WORCESTER COUNTY PLANNING COMMISSION AGENDA

Thursday, December 5, 2024

A. Sunset Marine Park – Major Site Plan Review

B. Eastern Shore Natural Gas – Major Site Plan Review

ENGINEERING PLAN
COVER SHEET

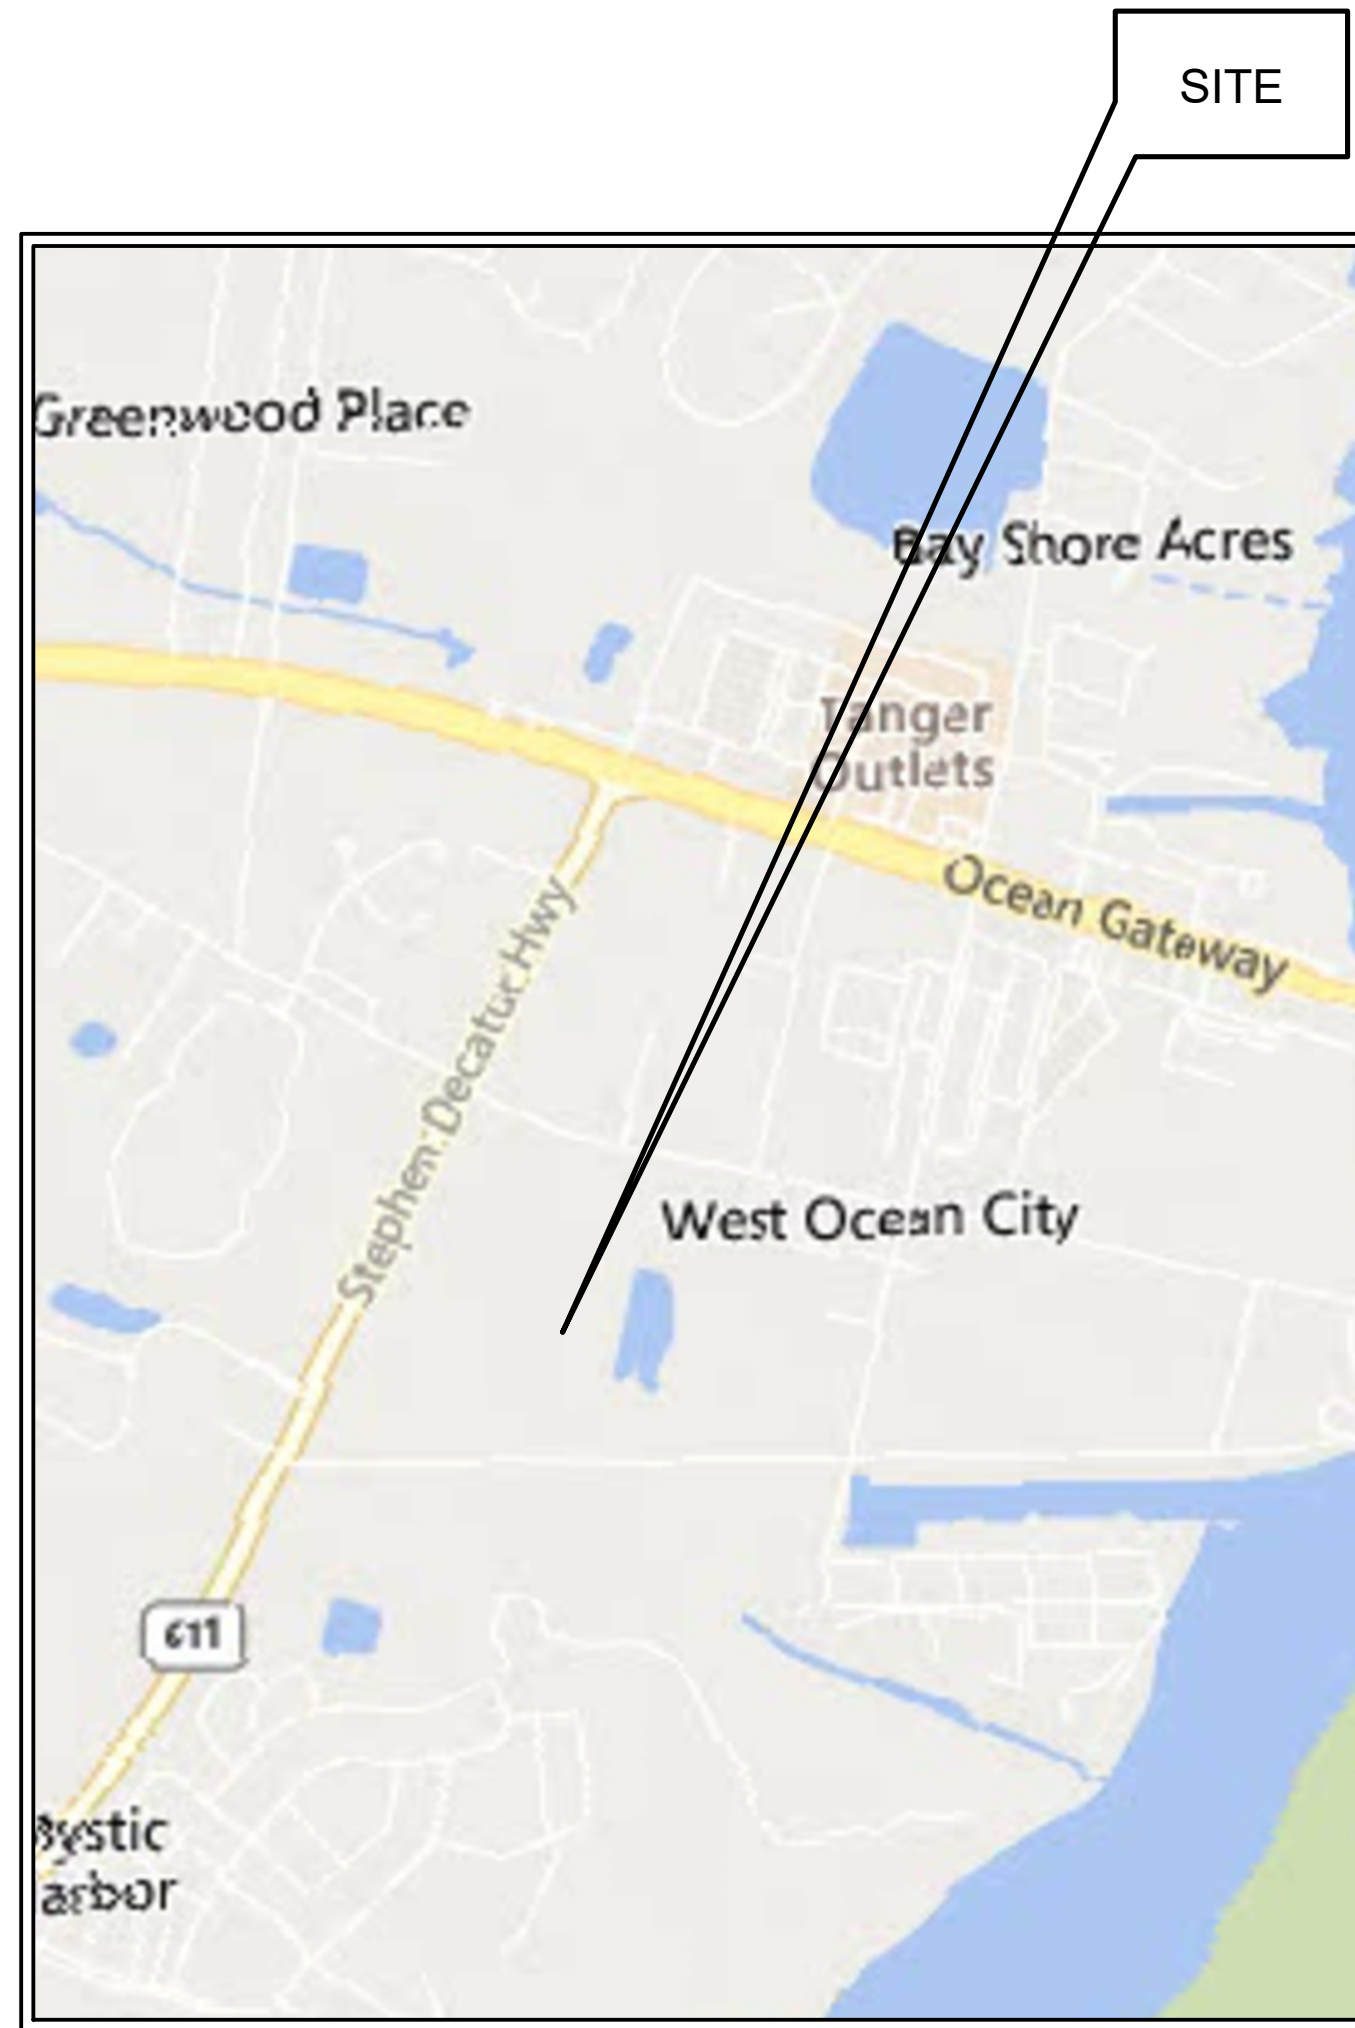
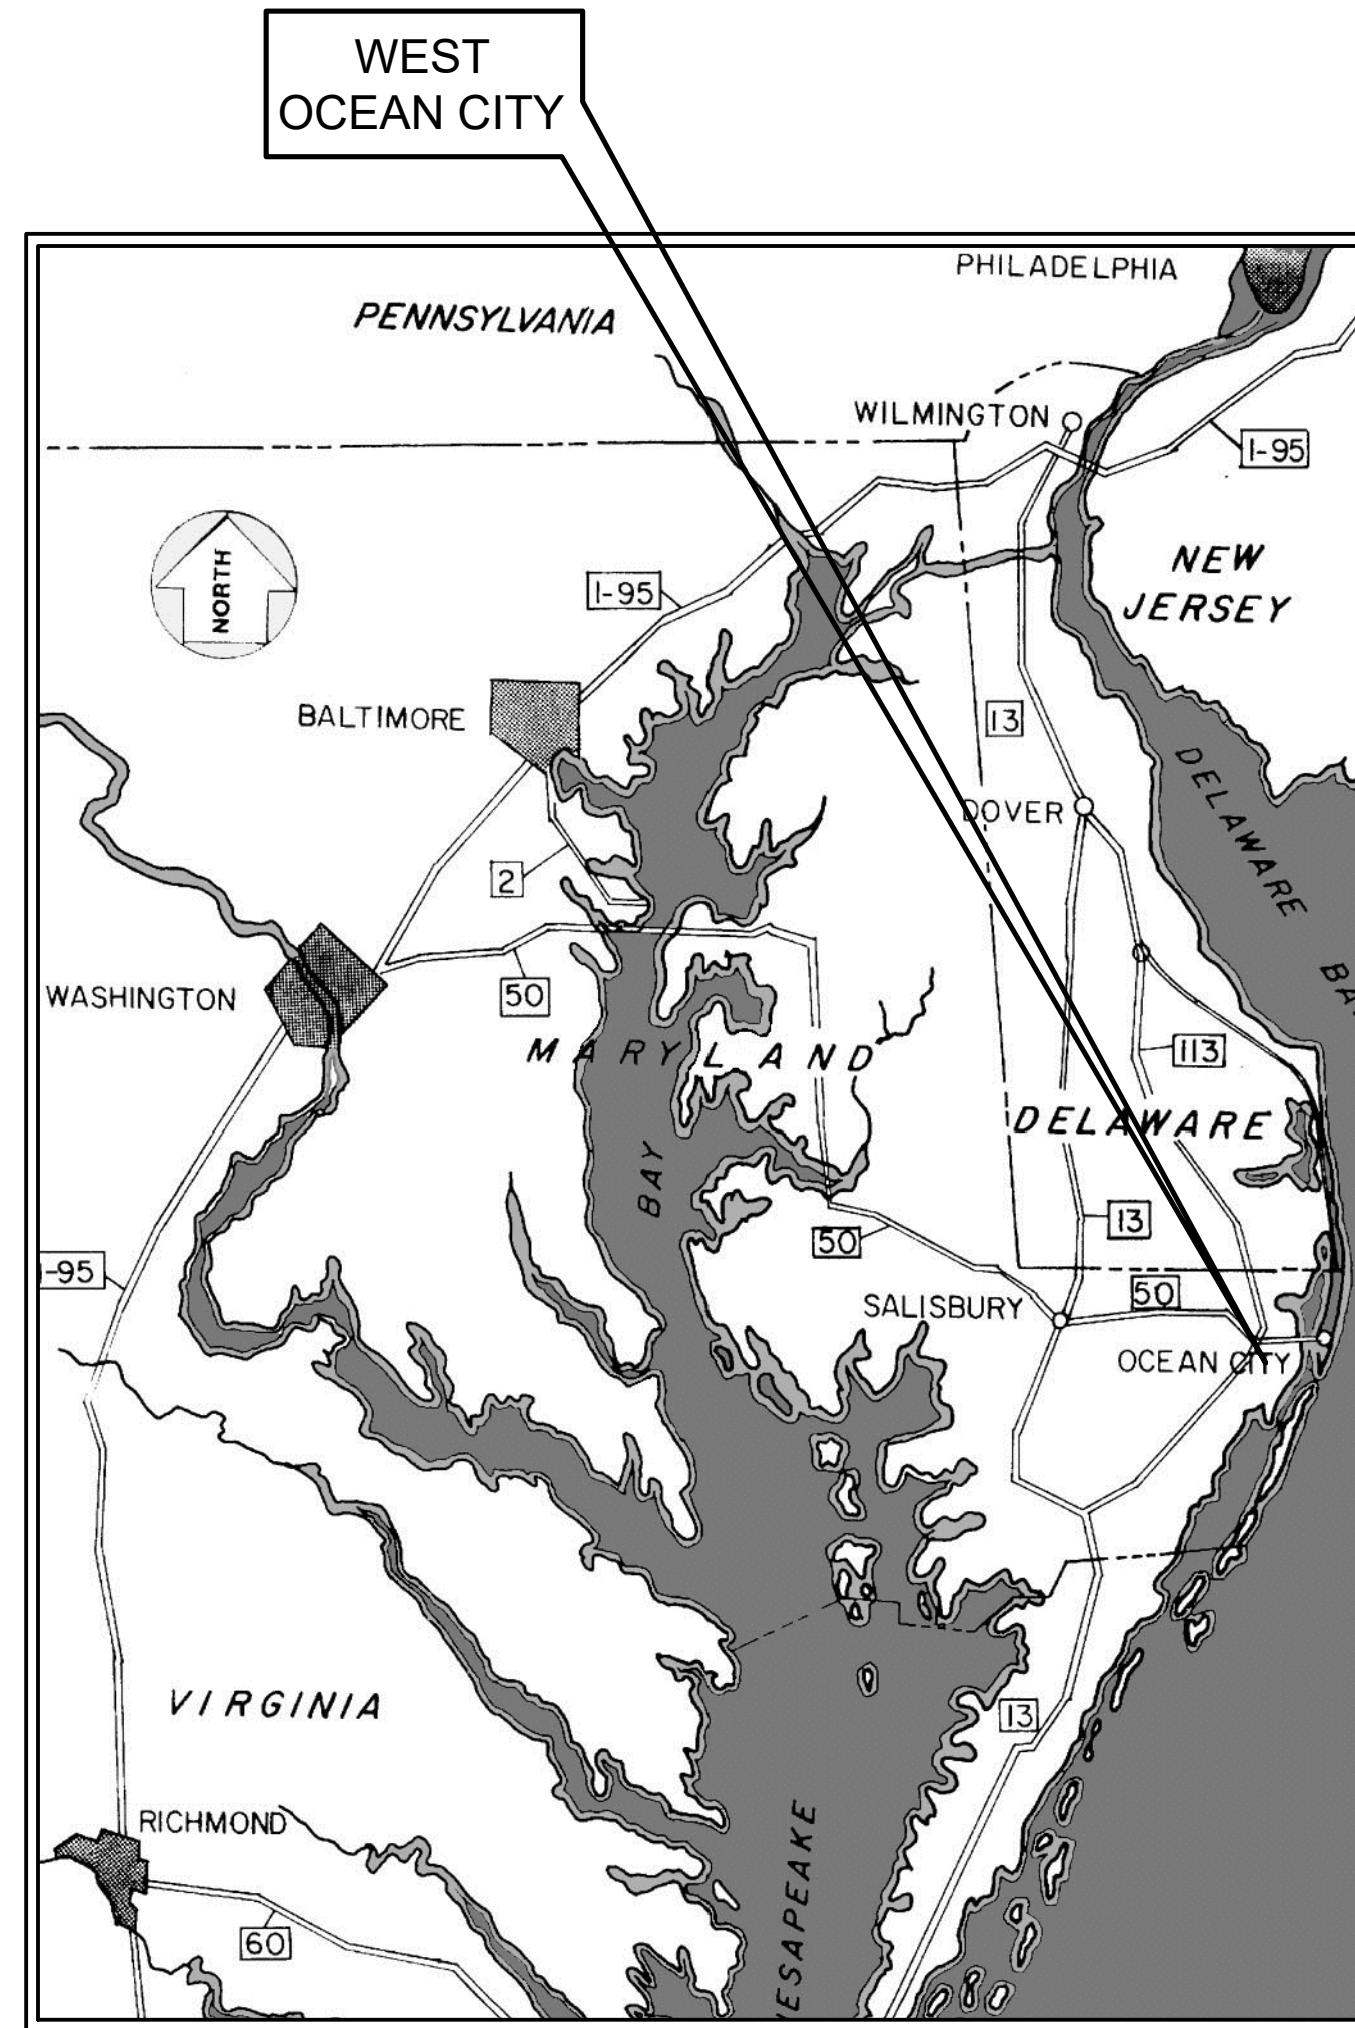
1. Please remove the reference to 'Retail Store' from the site data on sheet G1.0.
2. If signage is proposed, please show on sheet G1.2.
3. Please include the locations of the wall packs as shown on the elevations on sheet G1.2.

Comment 4: Comment #10. The table on Sheet G1.0 indicates that there are 28 EDU's. I believe these are intended to be parking spaces. Please relabel.

Comment 1: Please correct the code section to "Worcester County Code sections "NR 3-120" on the Construction Note #17 on sheet G1.0 and General Note #20 on sheet G1.1.

Response 11: *Building 01 is no longer within the scope of these plans and has been removed from these plans. The EDU requirements for the Watercraft Service Facility have been provided on Sheet G1.0.*
